SSD7881 (DA2a)

Supplementary Response to issues raised by City of Sydney (CoS) submission

Figure 1- Function Centre Lateral Wall Opening Sizes

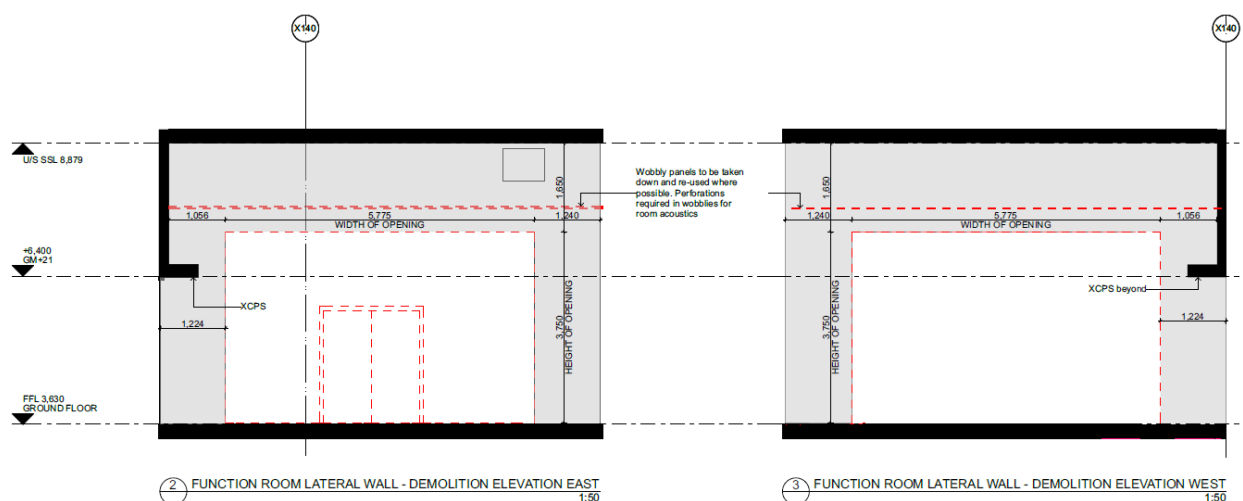
Following the meeting on the 19th January 2017 the City re-iterated that proposed irreversible internal changes and the demolition of a portion of the curved corridor to form the Function Centre should be carefully reconsidered and limited to that which is absolutely necessary.

- There is no reference in the Utzon Design Principals that directly contradicts the use of the space as a function centre instead of a restaurant.
- The removal of the significant fabric was noted in the Heritage Impact Statement. However, the Opera House considers that the proposed openings outlined in Figure 1 below are justified, and absolutely necessary.

The structural opening proposed by the Sydney Opera House is 5775mm (w) x 3650mm (h). This differs to the information provided in the original EIS as refinement of the structural analysis has meant that more of the wall can be retained. The size of these openings has also been workshopped with architects, TZG, and the Eminent Architects Panel, as detailed by TZG in their attached letter. The size of the proposed openings are considered to be the right balance between preserving heritage structure and introducing functionality & connectivity between the spaces.

Figure 4- Existing Secondary Rehearsal Room (GR +012)

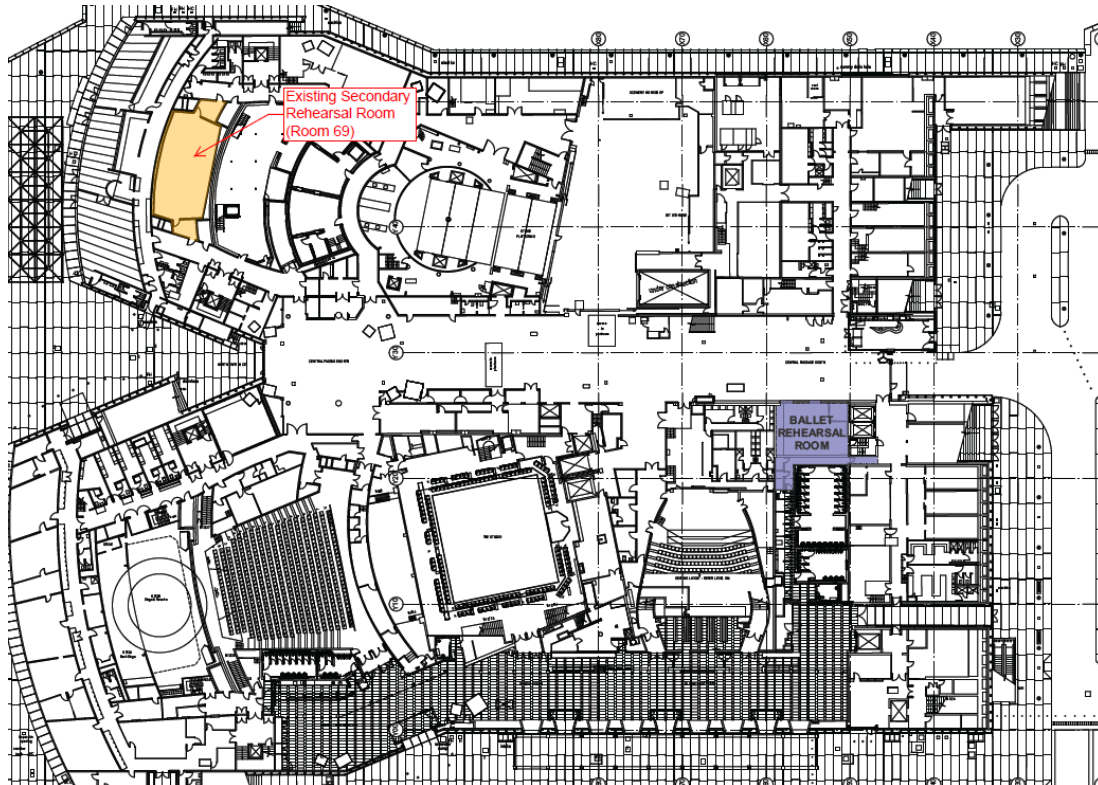
- Jørn Utzon's concept was to group rehearsal and preparation spaces beneath their related auditorium, which resulted in four rehearsal rooms being located beneath the minor hall (now JST), and a much larger rehearsal hall beneath the major hall (now Concert Hall). This proposal removes the last remaining rehearsal room from beneath the JST, relocating it to a distant location on the other side of the central passage.

- The proposed new location for the ballet rehearsal room is approximately two minutes' walk from the auditorium. It is also remote from the performers' dressing room and other facilities and requires performers to cross the central passage to access it. This arrangement is incompatible with the Opera House's status as a world class state of the art performing centre. While the application states this arrangement is temporary, there is no plan in place for a more suitable permanent location. Accordingly the Consent Authority must consider this arrangement as potentially permanent.

- The concept of Jørn Utzon was not fully realised in practice as the main rehearsal room for the Joan Sutherland Theatre is located under the Concert Hall and not the JST. This main rehearsal room is referenced in the Conservation Management Plan 3rd Edition however the secondary rehearsal room affected by the proposal is not. The main rehearsal room (room 54) is located off the green room from level 1 (+30), whereas the secondary rehearsal room (room 69) is located on level GR (+012).

The main rehearsal room is un-affected by the proposed works and the location of the proposed future rehearsal room is on the same level (GR, +012) as the existing secondary rehearsal room.
